# PMA Clause 120

## Technical Completeness and 200G Additions

Steve Trowbridge

# Example Left/Right 200G Figure

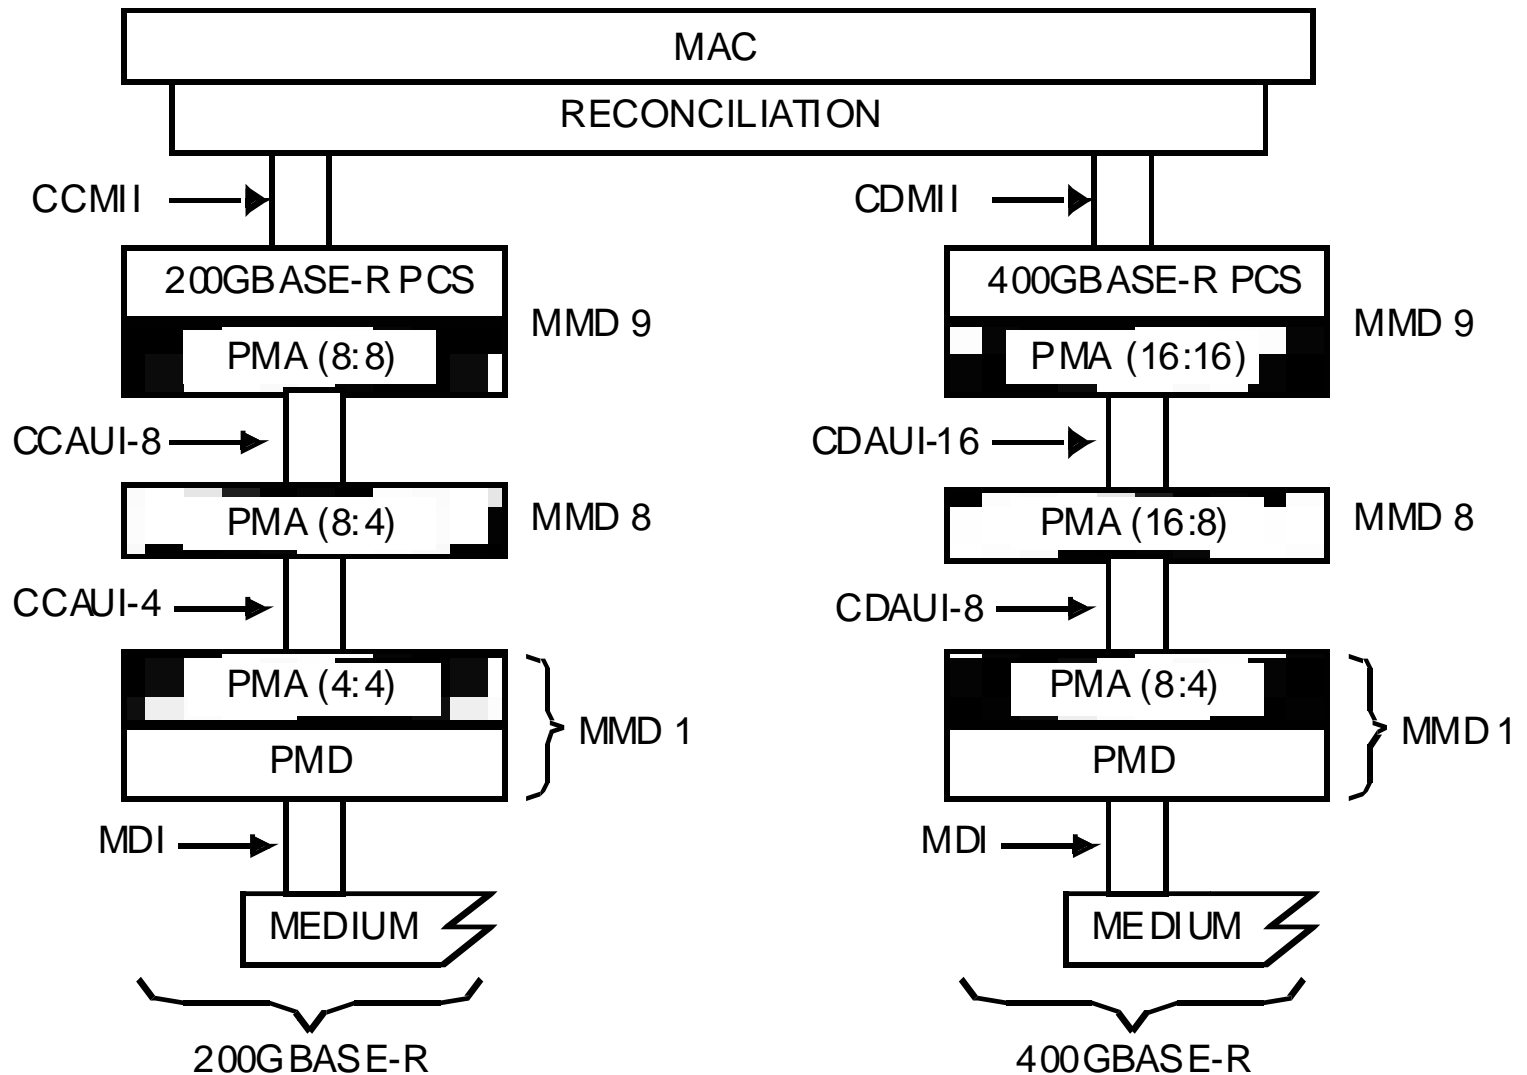
- Global change 400GBASE-R to 200GBASE-R and 400GBASE-R
- Global change CDAUI-8 to CCAUI-4 and CDAUI-8. Global change CDAUI-16 to CCAUI-8 and CDAUI-16
- Number of PCS lanes for 200G is 8. Number of PCS lanes per physical lane for 200G is 8/p.
- Major capabilities/options: add \*PCS200G and \*PCS400G. LANES\_UPSTREAM can be 8 or 16 for 400G and 4 or 8 for 200G. LANES\_DOWNSTREAM can be 4, 8 or 16 for 400G and 4 or 8 for 200G.
- PAM4 is when number of lanes is 4 or 8 for 400G or the number of lanes is 4 for 200G
- Redraw Figures 120-1 and 120-2 with 200G and 400G stacks left and right (similar to showing 40G and 100G in clause 83)
- Skew numbers for 200G are the same as for 400G. Delay numbers are the same value in ns with half the bits and half the pause quanta.
